REVIEW OF PROPOSED 5 FOOT DAM RAISE
UPPER TAILINGS POND EMBANKMENT SYSTEM
LISBON VALLEY OPERATIONS
RIO ALGOM CORPORATION

U.S. Nuclear Regulatory Commission
NMSS

John D. Nelson and Steven R. Abt
Geotechnical Engineering Program
Civil Engineering Department
Colorado State University
Fort Collins, Colorado 80523

October 1, 1980

Fig. 2.1 Plot Plan of Upper Tailings Impoundment (Source: ref. 3)

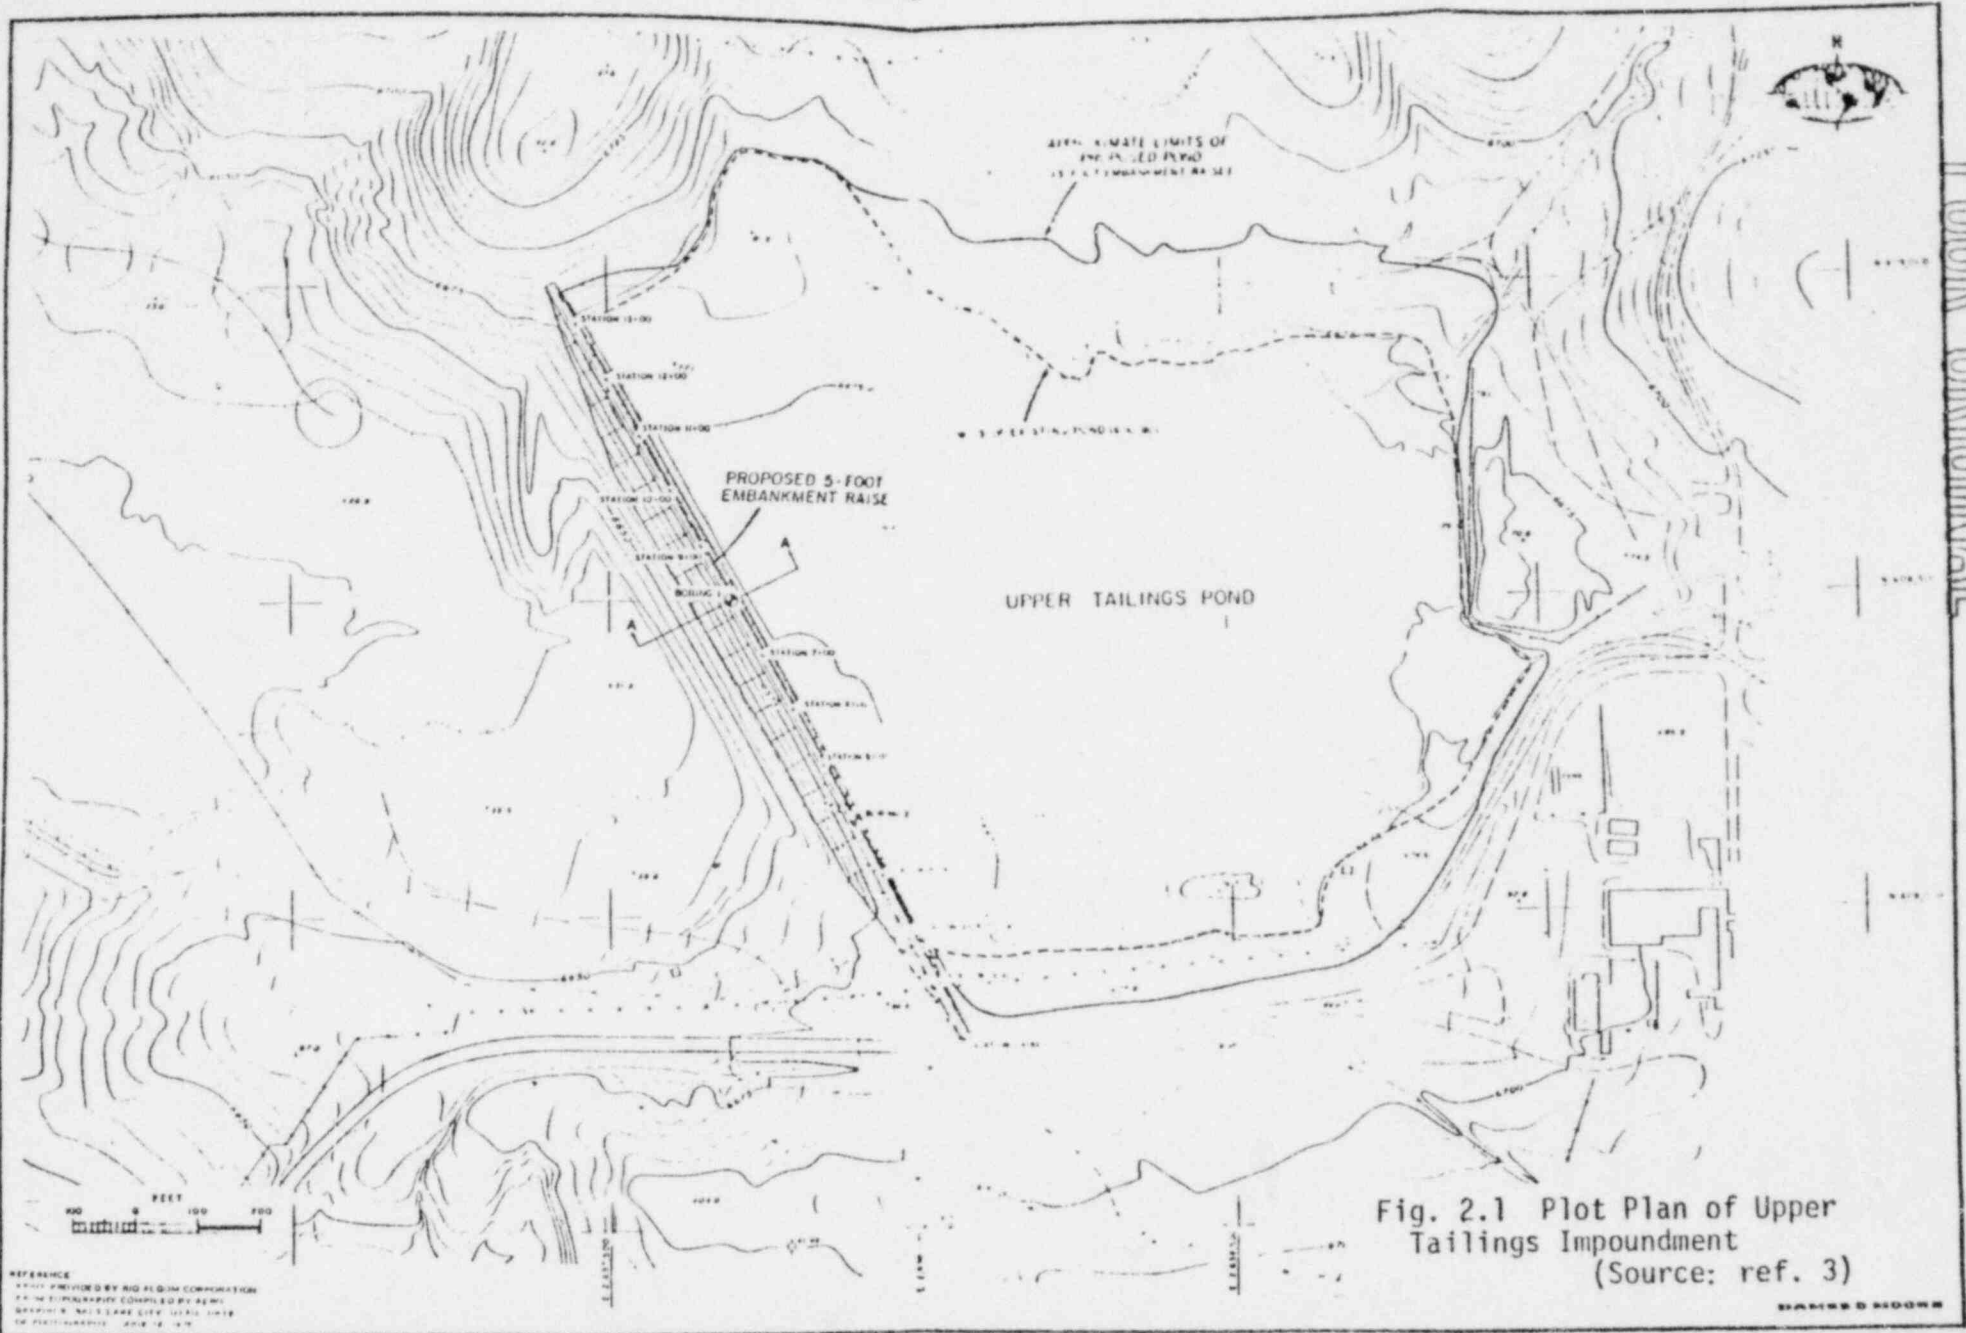
Borings were advanced at locations 1 and 2 as shown in Figure 2.1.

Fig. 2.2 Critical Embankment Section Analyzed
 (Source: ref. 3)

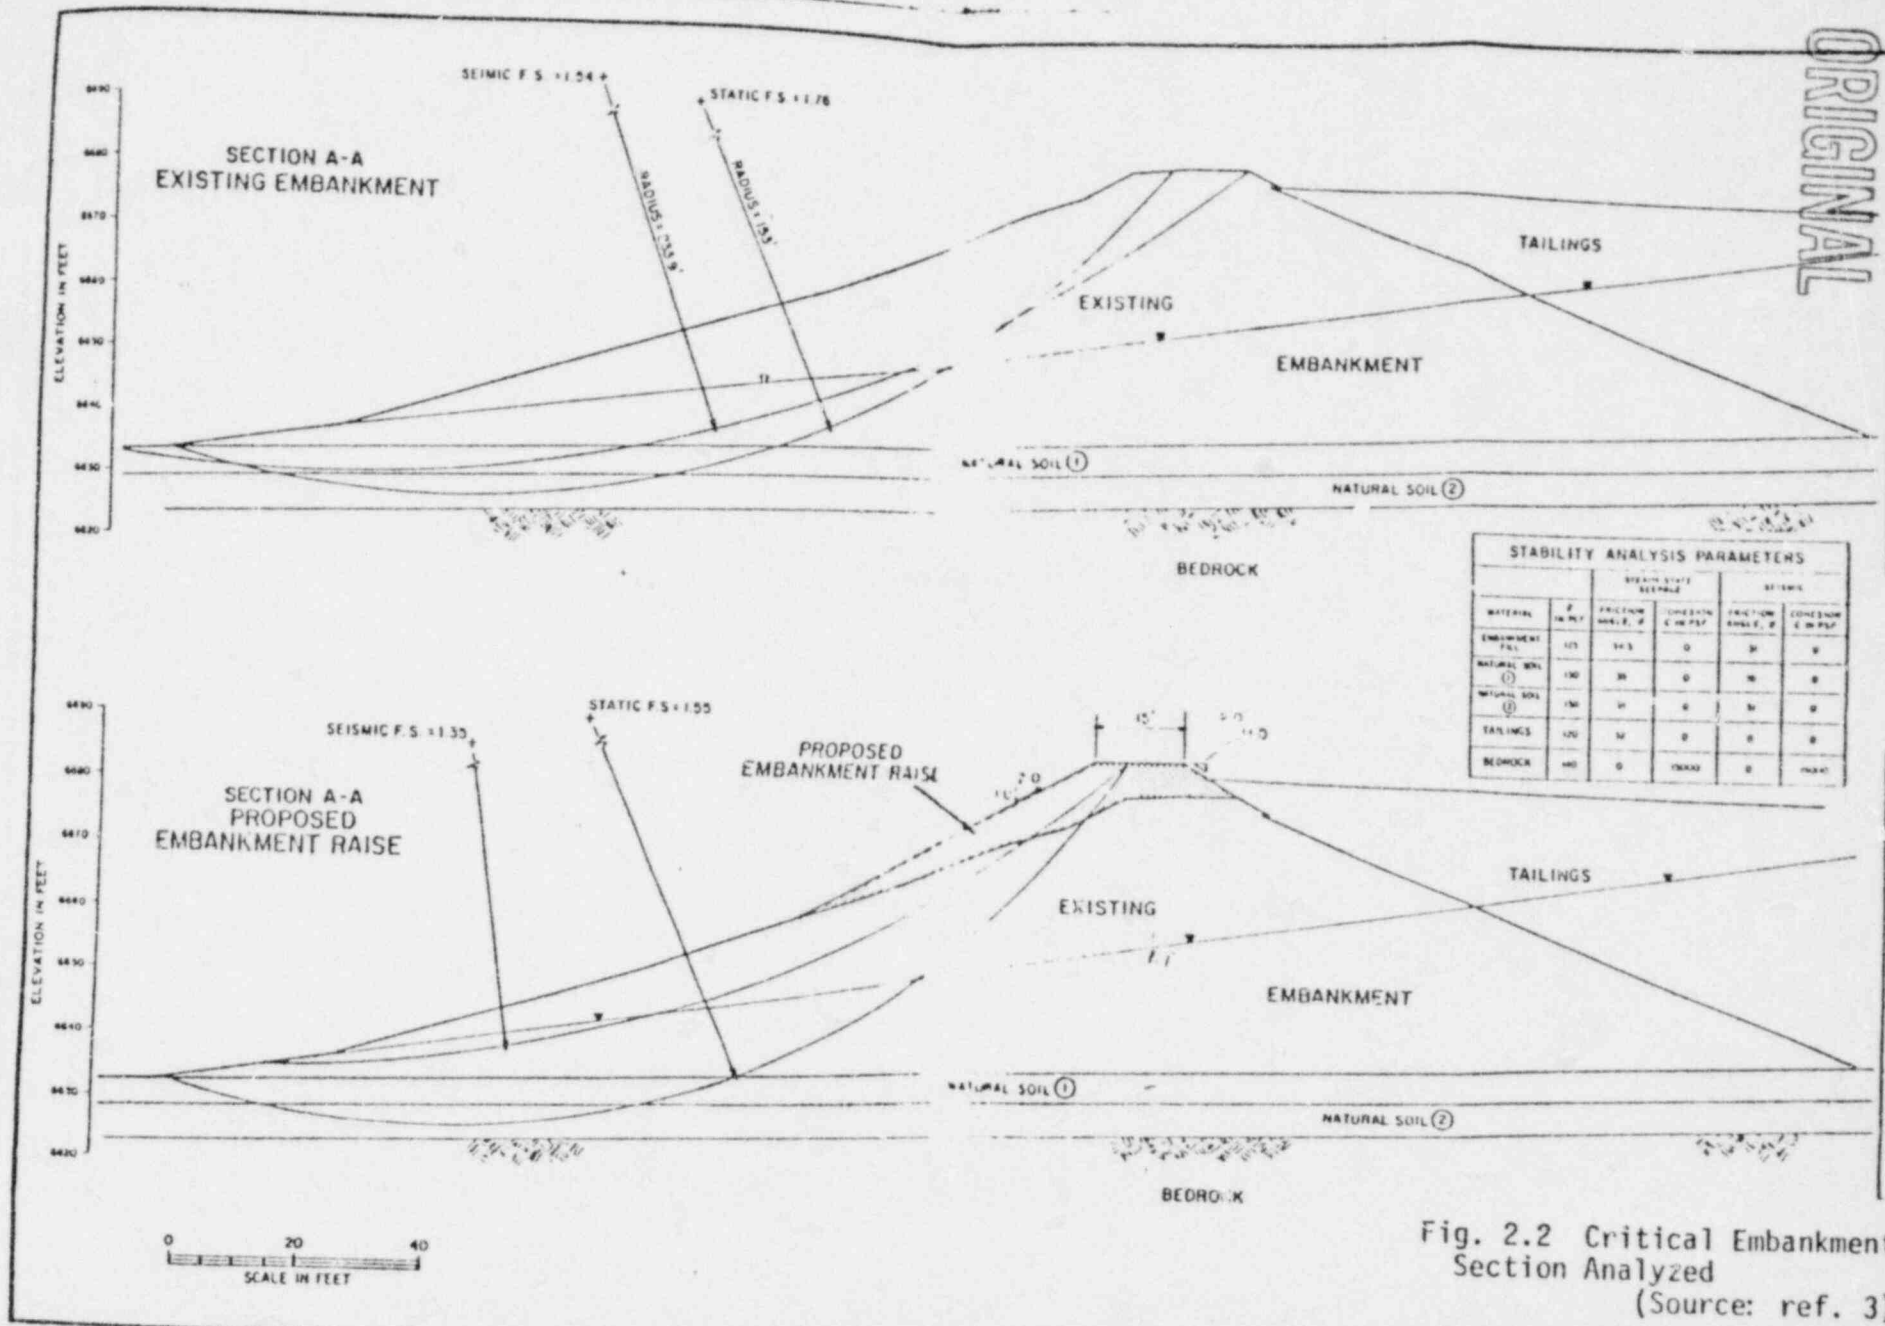
Shear strength values for the natural foundation soils as shown in Figure 2.2 were not substantiated with laboratory data. Furthermore, laboratory test data presented in the Dames and Moore report dated October 2, 1973 (ref. 1) indicate that shear strength values considerably lower than those that were assumed for the stability analyses may exist in the foundation soils. The reviewers, therefore, conclude that inadequate shear strength data for the natural foundation soil has been presented.

The boring logs that were presented in reference 3 indicated that bedrock had not been encountered in the borings. A subsequent letter from James R. Boddy of Dames and Moore dated September 11, 1980 to Rio Algom (ref. 5) indicates that bedrock was, in fact, encountered. Furthermore, in reference 3 the critical embankment section (as shown in Figure 2.2 of this report) indicates two strata of natural soils. The basis for representing the natural soil in two distinct strata with different shear strengths is not presented and the boring logs do not indicate any basis for doing so. Also, on page 7 of reference 3 it is stated that a cutoff barrier was extended to competent bedrock. This cutoff barrier is not indicated in the critical embankment for stability analyses. It is concluded, therefore, that the critical embankment section as shown in reference 3 (Figure 2.2 of this report) does not represent the actual existing conditions with regard to geometry and shear strength of the foundation soils.

The phreatic surface within the embankment that was assumed for purposes of stability analyses is shown in Figure 2.2. However, the boring logs indicate that to the entire depth of soil overlying the bedrock, no groundwater was encountered. Furthermore, piezometers placed at depths of 31.5 feet in boring 1 and 28.5 feet in boring 2 indicated no water at the time reference 3 was prepared. The two piezometers, however, were located near the top of the location of the phreatic surface as shown in Figure 2.2. Consequently, they are not capable of locating a phreatic surface even slightly lower than that. It

The factors of safety that were computed appear to be adequate. Although the Bishop's method of analysis indicated a factor of safety slightly lower than 1.5 the assumed phreatic surface is believed to be higher than what actually exists, and therefore, would generate factors of safety lower than what actually exists. Some question, however, exists as to the adequacy with which the conditions that were analyzed represent the actual conditions.

4.3 Page 7 of reference 3 indicates that a cutoff trench was excavated and recompactd beneath the embankment. However, the critical embankment section that was analyzed and is reproduced as Figure 2.2 in this report does not indicate that cutoff wall. The effect of that cutoff on the stability analyses should be discussed. Plate 4 in reference 3 (reproduced as Figure 2.2 herein) should be revised to indicate that such a cutoff does exist if it does, or else the text should be revised. Because the inspection report as presented in Appendix B of reference 3 indicates that a cutoff trench was excavated, the reviewers believe that Plate 4 (ref. 3) is incorrect and that the stability analyses should be revised.

4.4 The boring logs and the piezometers indicate that the phreatic surface shown in Plate 4 of ref. 3 (see Fig. 2.2) is incorrect. It is not uncommon for the phreatic surface within an embankment to be lowered by a highly permeable natural foundation soil or through highly permeable bedrock. It was indicated in reference 3 that the upper layers of the sandstone bedrock are weathered and it is possible that the seepage is occurring therein. However, it is also possible that seepage could be occurring through a layer in the natural foundation soils causing a zone of high water content with low strength. It is recommended that adequate sampling in the natural foundation soils should be accomplished to show that such a zone of high moisture content does not exist that

4.2 The basis on which the shear strength of the natural soils was assumed was not presented. The applicant should show by means of laboratory data or field tests that the assumed values of shear strength are in fact accurate. If this can not be demonstrated, revised slope stability analyses should be conducted.
